Re: Inspection Letter: HHF005 Spec Lot 5 Homestead at Hook Farms 1st Plat – 2022 SW Farm Field Ln., Lee's Summit, Missouri

Vista Structural Engineering, LLC was asked to address the following rough-in inspection items for the project located at above referenced address. Please see the following responses w/ attached partial plan mark up, calculations, and site photos for reference.

ROOF, KING STUD CONT. HDR
2 piece(s) 2 x 6 DF No.2

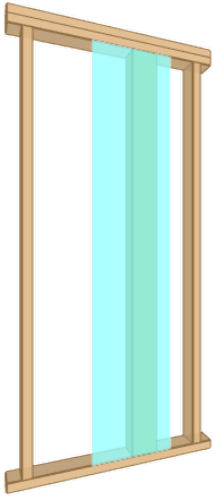
- 1) **Inspection comment:** Header framing at Great Room differs than on plan. Header is continuous with triple full height trimmers between windows w/ double triple trimmers and (1) king stud at ends (Great Room stud height = 18'-0").

Vista Structural's response: *We recommend approval of the current framing of the continuous header and intermediate tall stud trimmers. Single King Stud at ea. end of header is not acceptable. GC to install (1) additional 2x6 king stud each end w/ (1) Simpson A35 top & bottom. Please see attached plan mark up, calculation, and ref. photo.*

MAIN FL (UPPER FL FRAMING) - GREAT ROOM PARTIAL PLAN

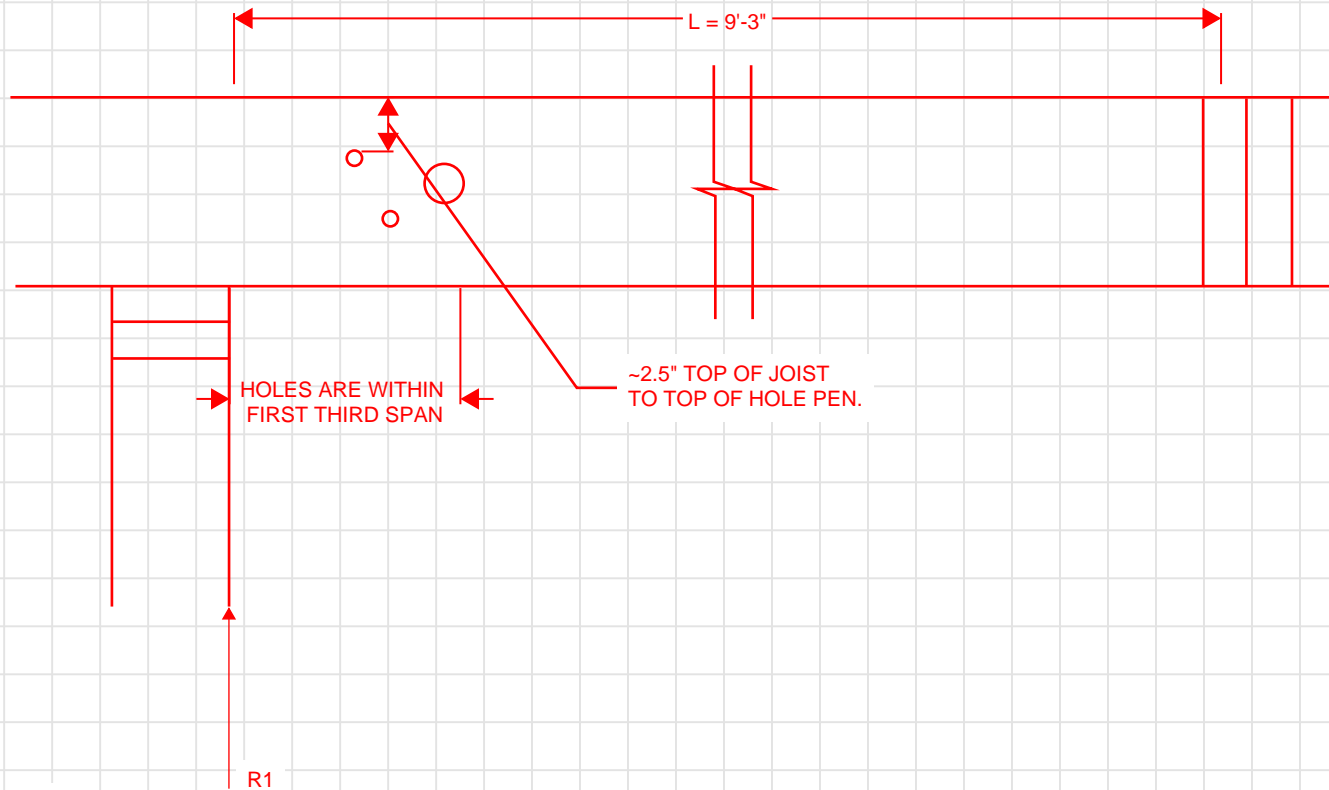
- 2) **Inspection comment:** Plumbing penetrations in upper floor joists (near bearing wall between Master Suite/Bath).

Vista Structural's response: *Per the attached calculations, the holes are near the end of the joists, where bending stresses are very low, and shear stresses govern. The depth of the holes, from bottom of the lowest hole to the top of the highest hole, is limited to approximately 2 ½". Based on the attached calculations, the resultant shear stress in the reduced section is only 84 psi, which is much lower than the allowable shear stress of 180 psi (per 2018 NDS). Therefore, we recommend approval of the joists as they are currently constructed, without any upgrade/replacement. Please see attached plan mark up, calculation, and ref. photo.*
